Energy to Serve Your World™
NL-04-2326

Joseph M. Farley Nuclear Plant Units 1 and 2
Response to Request for Additional Information Related to
Request to Revise Service Water Intake Structure Exemption From Fire Protection
Requirements at Farley Nuclear Plant

**Joseph M. Farley Nuclear Plant Units 1 and 2
Response to Request for Additional Information Related to
Request to Revise Service Water Intake Structure Exemption From Fire Protection Requirements
at Farley Nuclear Plant**

SNC Response to NRC Requests for Additional Information

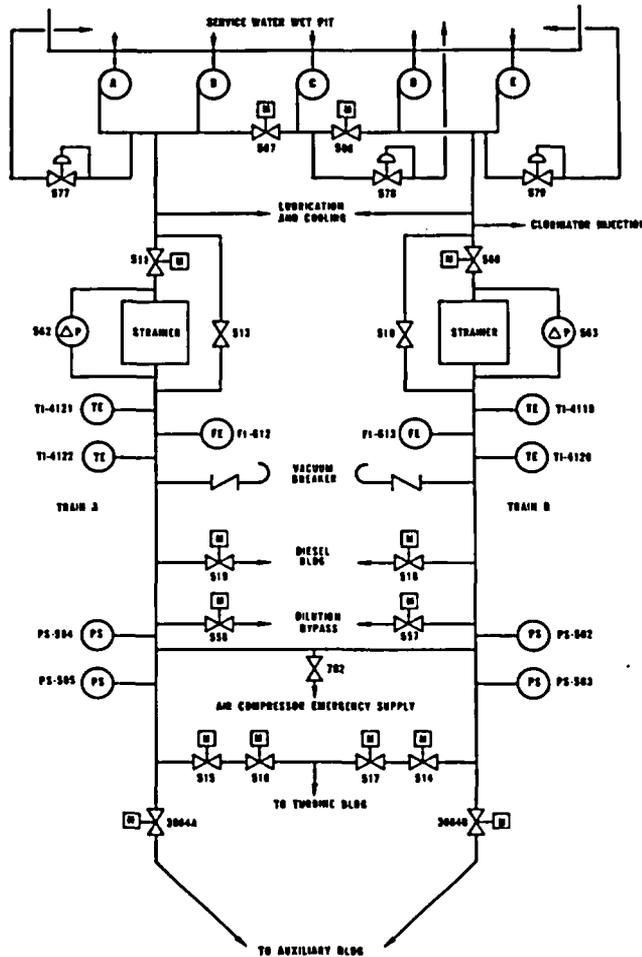
NRC Question 1

“In addition, SNC determined that certain cables for MOVs that align the swing Service Water pump discharge valves no longer require reliance on Kaowool. Service water alignment procedures remove power from these valves, thus precluding spurious valve operation.”

The procedures for realignment of the swing Service Water pump are structured such that the discharge valves which provide train separation are powered only during the time required to correctly position the discharge valves. That is, the power supply breakers are closed by an operator in the Service Water Structure, the two valves are repositioned one at a time using the main control board handswitches, and the power supply breakers are opened. The on-service train alignment is changed approximately every two weeks to facilitate scheduled plant maintenance. Power is supplied to the valves for less than ten minutes during each train realignment evolution. Therefore, the valves would normally be powered for less than 260 minutes per unit per year or 520 minutes total per year. The generic fire frequency for the Service Water pumps is 8.00E-03/year per unit. The resulting probability of Service Water pump fire during a period when the discharge valves are powered is 3.96E-06 per unit.

Following is a simplified diagram of a single unit's Service Water system. The valves labeled "506," "507," "511," and "508" are the valves of concern.
